HOPE CREEK GENERATING STATION DOCKET NO. 50-354 DRAFT SAFETY EVALUATION REPORT OPEN ITEM STATUS

Attachment 1 is a current list which provides a status of the open items identified in Section 1.7 of the Draft Safety Evaluation Report (SER). Items identified as "complete" are those for which PSE&G has provided responses and no confirmation of status has been received from the staff. We will consider these items closed unless notified otherwise. In order to permit timely resolution of items identified as "complete" which may not be resolved to the staff's satisfaction, please provide a specific description of the issue which remains to be resolved.

In addition, enclosed for your review and approval (see Attachment 4) are the resolutions to those Draft SER open items listed in Attachment 3.

TABLE 3.9-10

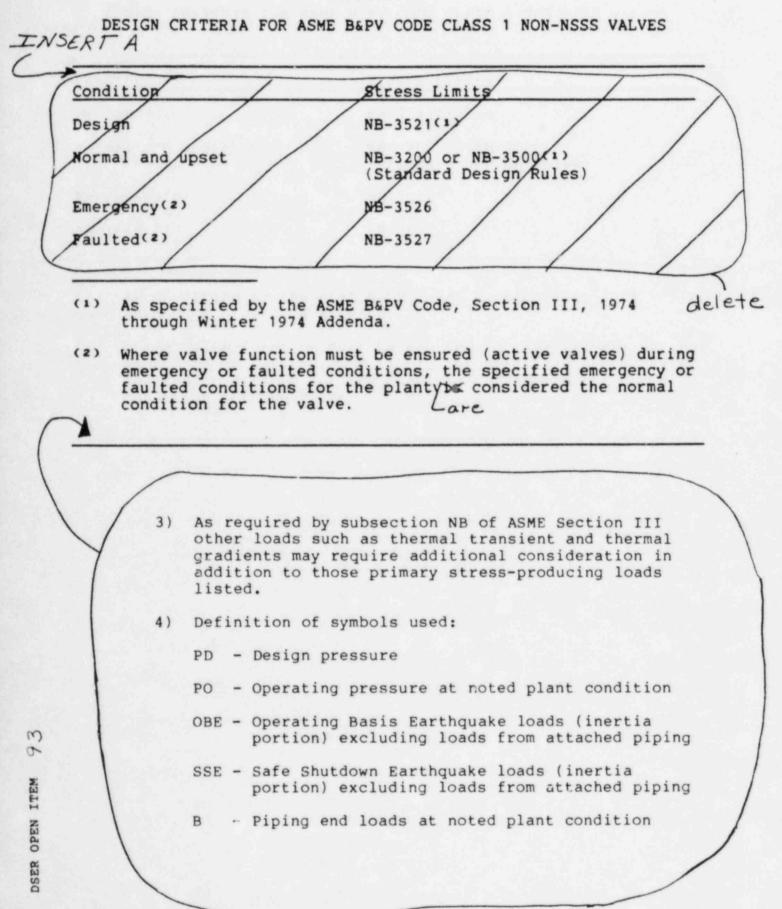
More information is required on loading combinations, system operating transients and stress limits for each of the following for all classes of construction: vessels, pumps, valves, piping, and supports. Assurance must be provided for the functional capability of ASME Class 1, 2, and 3 piping systems. This is an open item.

Tables 3.9-10 and 3.9-15 have been revised to include the loading combinations and allowable stress limits for non-NSSS Class 1 valves and Class 2 and 3 valves respectively. Informaticn on loading combinations, system operating transients, and stress limits for pumps were provided in response to Question 210.52. Information on safety-related vessels designed to the ASME Code are attached in Tables 93-1 and 93-2.

INSERT A T3.9-10

Plant Condition	Design Loading Combinations (4)	Stress Limits (1)
Design	PD	The valve shall conform to the
Normal	POn + Bn	requirement of Paragraph NB-3500 (Standard Design Rules)
Upset (3)	POu + OBE + Bu	NB 3525
Emergency (2)	POe + Be	NB 3526
Faulted (2)	POf + SSE + Bf	NB 3527
